RENESAS TECHNICAL NEWS

No.M380-31-0305

Corrections and Supplementary Explanation for 3804 Group Data Sheet and User's Manual

Concerned Products
 3804 Group

1-1. Page 1-74 Fig.67 Structure of I²C control register
 I²C control register (S1D: address 0014₁₆)

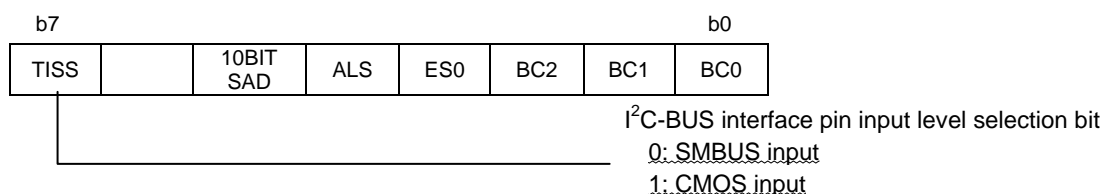
A few corrections concerning I²C-BUS interface explanation exist in "3803/3804 Group Data Sheet (Rev. 4.0)" and "3803/3804 Group User's Manual (Rev. 3.0)". When using these documents, please take note of the following.

[Previous change]

[After change]

1-4. Page 3-56 Fig.3.5.9 Structure of I²C control register (only for 3804 Group)

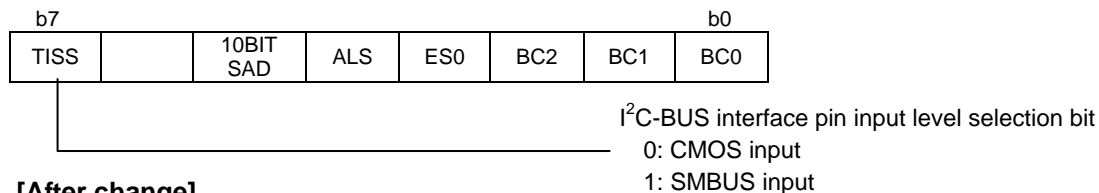
Revise the explanation of the I²C-BUS interface pin input level selection bit as well as 1-1.

2-1. Page 73 Fig.67 Structure of I²C control register

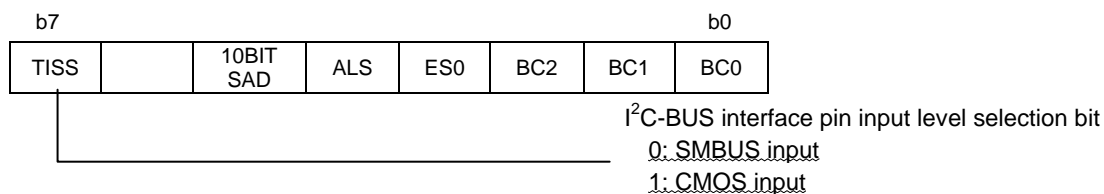
I²C control register (S1D: address 0014₁₆)

[Previous change]

[After change]

[3804 Group: I²C control register: S1D (address 0014₁₆)]

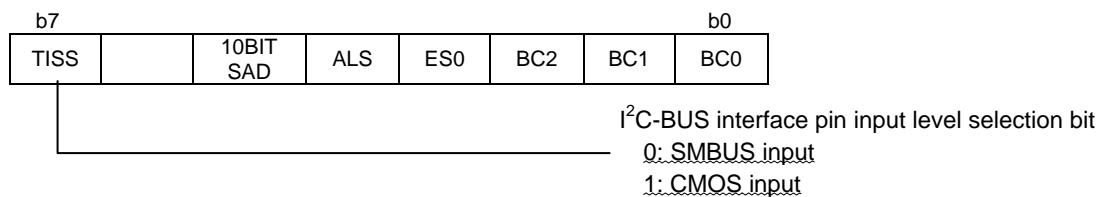
3. Note that there are differences of the I2C-BUS interface pin input level selection bit as follows among the 3804, 3851, 3886 and 7516 Groups.
